Corrections of Hardware Manual

MB90560/5 -

HM90560_add_V101

Addendum, MB90560/5 Hardware Manual (CM42-10107-4E)

Power-On Reset

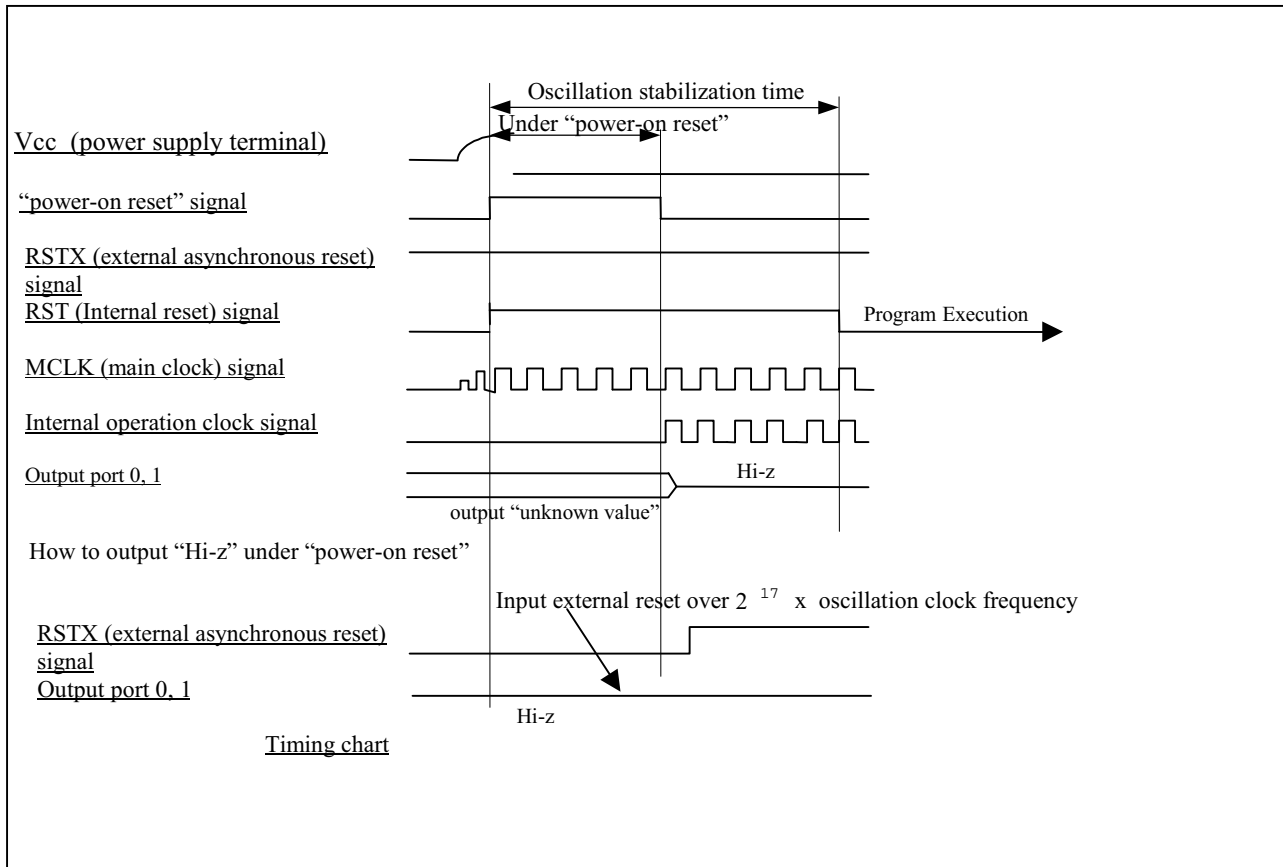
Output "unknown value" , when the power supply is turned on if F²MC-16LX is used. (Note)

During testing it has been found that some port pins may enter an undefined state during power on. By asserting RSTx during the power on reset (2^{17} cycles of main clock) port pins can be forced to high impedance.

The following Ports will output a High Impedance (Hi-z) at the terminal when the power supply is turned on when PONR and RSTX = 1:

P40 - P67

The following ports will output High Impedance (High-Z) on RSTX or with the End of PONR and Start of internal clocks:

P00 - P17

The following Ports will output High Impedance (high-Z) with the End of PONR and Start of the internal Clock. RSTX does not force the pins to high-Z during power on.

P20 - P37

This workaround will work for Mode pin setting 011 (Single chip, Internal ROM external bus), 110 (Burn_In ROM), 111 (EPROM mode)

The following diagram shows the timing chart in detail.

Under “power-on reset” 2^{17} x oscillation clock frequency
 (8.192ms in case of oscillation clock frequency = 16MHz)

Waiting time to be stabilized oscillation 2^{18} x oscillation clock frequency
 (16.384ms in case of oscillation clock frequency = 16MHz).
